DEVELOPMENT APPLICATION ASSESSMENT REPORT

Application Number:	DA2021/0179
Responsible Officer:	Rebecca Englund
Land to be developed (Address):	Lot 8 DP 604034, 255 Condamine Street MANLY VALE NSW 2093
Proposed Development:	Construction of a boarding house development
Zoning:	Warringah LEP2011 - Land zoned B2 Local Centre
Development Permissible:	Yes
Existing Use Rights:	No
Consent Authority:	Northern Beaches Council
Delegation Level:	NBLPP
Land and Environment Court Action:	Yes
Owner:	My Manly Vale Pty Ltd
Applicant:	My Manly Vale Pty Ltd
Application Lodged:	09/03/2021
Integrated Development:	Yes
Designated Development:	No
State Reporting Category:	Residential - Other
Notified:	22/03/2021 to 21/04/2021
Advertised:	22/03/2021
Submissions Received:	21
Clause 4.6 Variation:	4.3 Height of buildings: 78%
Recommendation:	Refusal
Estimated Cost of Works:	\$ 5,084,700.00

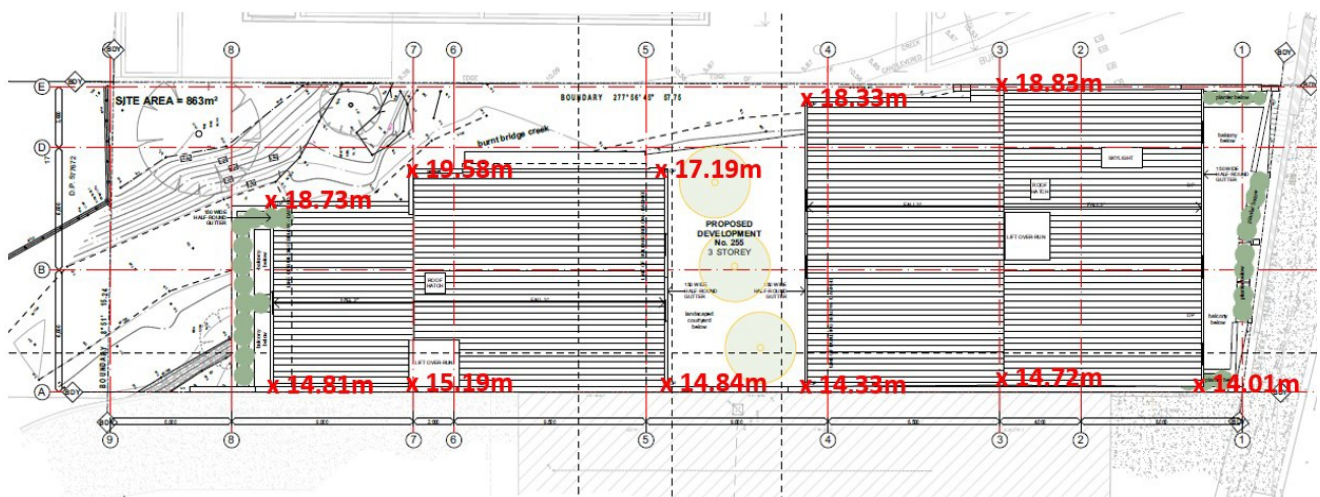
The proposed development reaches a maximum height of 19.58m, representative of a 8.58m or 78% variation to the 11m maximum building height development standard. The maximum height occurs in the central roof form of the rear building, where the development overhangs the creekline. Whilst the extent of non-compliance decreases across the remainder of the building, the entire top floor protrudes beyond the 11m height plane, with a minimum non-compliance of 3.01m at the front south-east corner of the front building. The height of varying parts of the building is best illustrated in the diagram below.

It is noted that Council's calculations differ from those nominated in the applicant's 4.6 submission by up to 3.23m or 29%. Upon review of the clause 4.6 submission, it appears that the applicant has measured the height of the development from the 11m height plane shown on the northern elevation (see Diagram 2, below). However, as evident in Diagram 2, the 11m height plane does not relate to the
